Section 33.7 Loss of management frame communication

Section 33.7.1 PSE loss of communication

PSE State Diagram

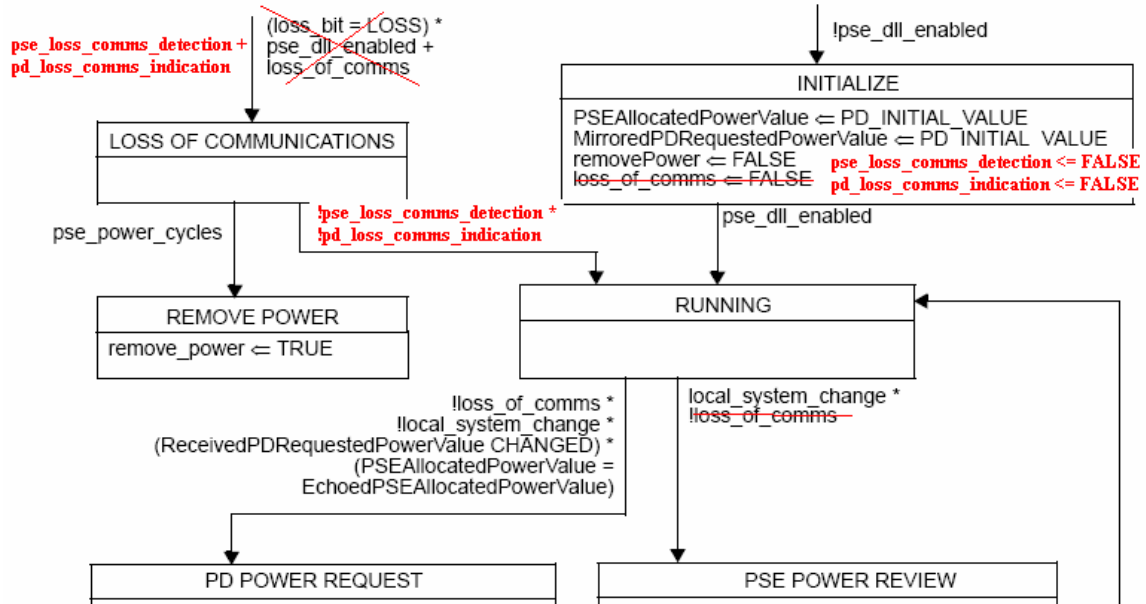
Add the following variables to section 33.6.6.2

Remove the variable loss_of_comms

pse_loss_comms_detection

This variable is mapped into the aLostCommunication attribute (30.9.1.1.21).

Values: TRUE: Loss of communication as defined in 33.7.1 has occurred in the PSE local system
FALSE: Loss of communication as defined in 33.7.1 has not occurred in the PSE local system

pd_loss_comms_indication

This variable is mapped from the aMirroredLostCommunication attribute (30.9.1.1.22).

Values: TRUE: Loss of communication as defined in 33.7.2 has occurred in the remote system and mirrored at the PSE
FALSE: Loss of communication as defined in 33.7.1 has not occurred in the remote system and mirrored at the PSE

PD State Diagram

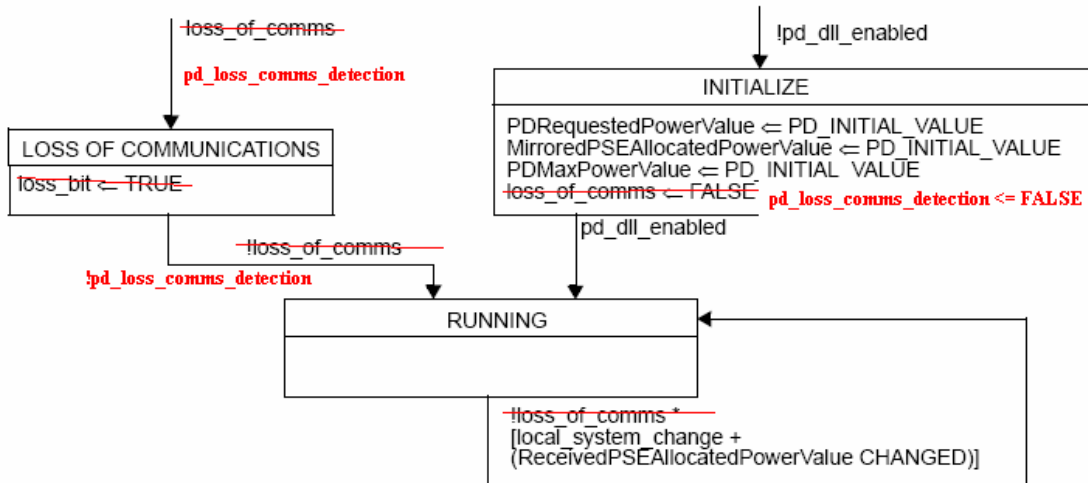
pd_loss_comms_detection

This variable is mapped into the aLostCommunication attribute (30.9.2.1.11).

Values: TRUE: Loss of communication as defined in 33.7.2 has occurred in the PD local system
FALSE: Loss of communication as defined in 33.7.2 has not occurred in the PD local system

Object	Attribute	Mapping	State diagram variable
oPSE managed object class	aDLLPSEAllocatedPowerValue	<=	PSEAllocatedPowerValue
	aEchoedDLLPSEAllocatedPowerValue	=>	EchoedPSEAllocatedPowerValue
	aReceivedDLLPDRequestedPowerValue	=>	ReceivedPDRequestedPowerValue
	aMirroredDLLPDRequestedPowerValue	<=	MirroredPDRequestedPowerValue
	aLostCommunication	<=	pse_loss_comms_detection
	aMirroredLostCommunication	=>	pd_loss_comms_indication
oPD managed object class	aDLLPDRequestedPowerValue	<=	PDRequestedPowerValue
	aReceivedDLLPSEAllocatedPowerValue	=>	ReceivedPSEAllocatedPowerValue
	aMirroredDLLPSEAllocatedPowerValue	<=	MirroredPSEAllocatedPowerValue
	aLostCommunication	<=	pd_loss_comms_detection
